MEMORANDUM

SUBJECT: Classification of Heating/Air Conditioning Return Flow Systems - UIC Well Classification Advisory #6

FROM: Thomas E. Belk, Chief
Underground Injection Control Branch (WH-550)

Figure 1.12

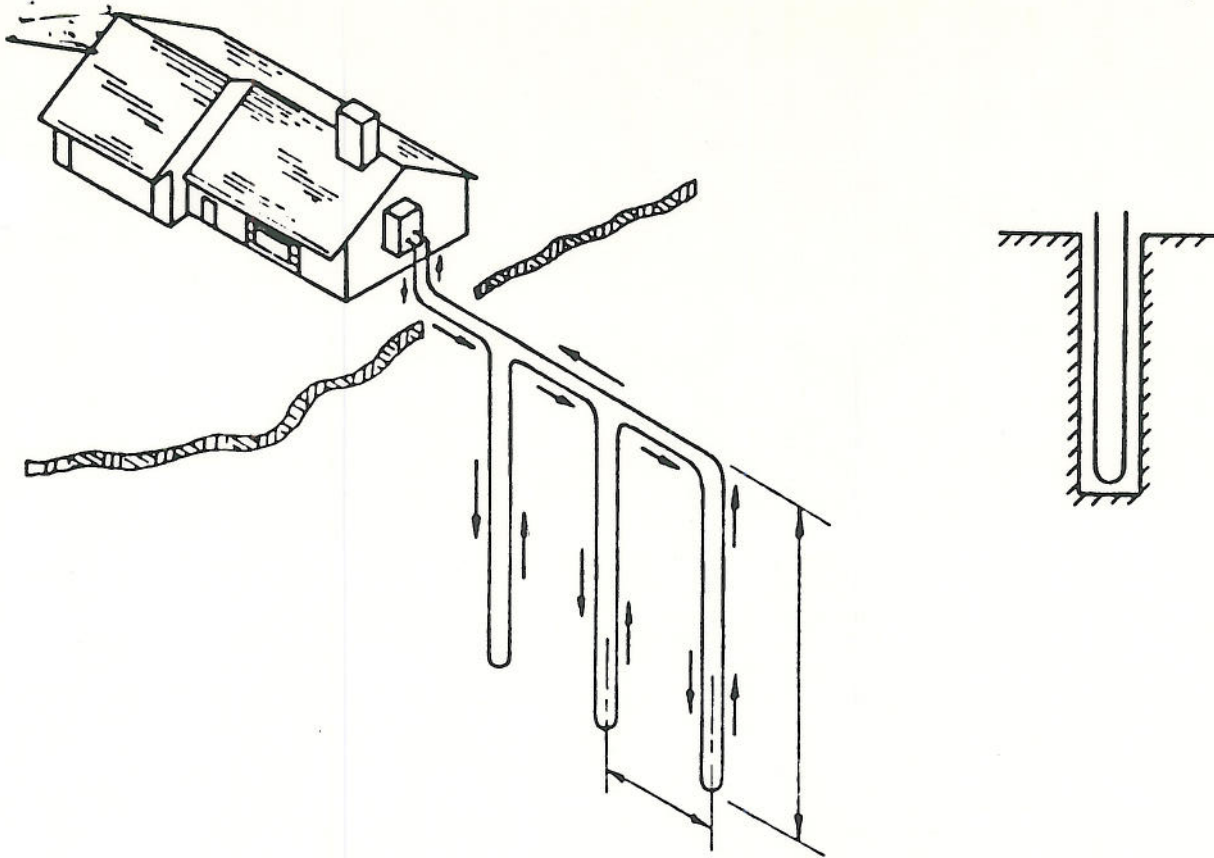
We are responding to your letter of December 11, 1984, requesting a clarification of the classification of the type of heat exchange system represented on Figure 1.12 entitled "Series Vertical Earth Coil" (copy attached).

From the diagram you provided, I presume that no water would be removed from the aquifer and returned to it. Also, I presume that some fluid other than water would be used within the system to avoid freezing, corrosion, etc. It would seem that such a theoretical system, if properly constructed and maintained would not meet the definition of a Class V well. However, two points are clear. First, such a system, if leaking, could be a threat to underground sources of drinking water. Second, the burden is upon the owner/operator to demonstrate that his system is not a Class V well. Therefore, the director certainly has the option to require the owners/operators of all such systems to submit inventory information, and proof of the proper construction of the well.

We are frequently asked if heating/air conditioning return flow systems are included as Class V wells under the federal UIC program. Although it is clear certain of these systems do utilize Class V wells it is not clear all designs may be included. The design in question is one which encompasses an earth coil (U-Bend) type construction. This is a continuous coil which does not release fluid into a subsurface formation, when properly maintained.

Attached are diagrams of three types of heat exchange systems. The type represented on "figure 1.12" entitled "Series Vertical Earth Coil" is the one in question. I would appreciate your interpretation of this systems' status under the UIC program. Does a properly constructed and maintained system qualify as a Class V well.
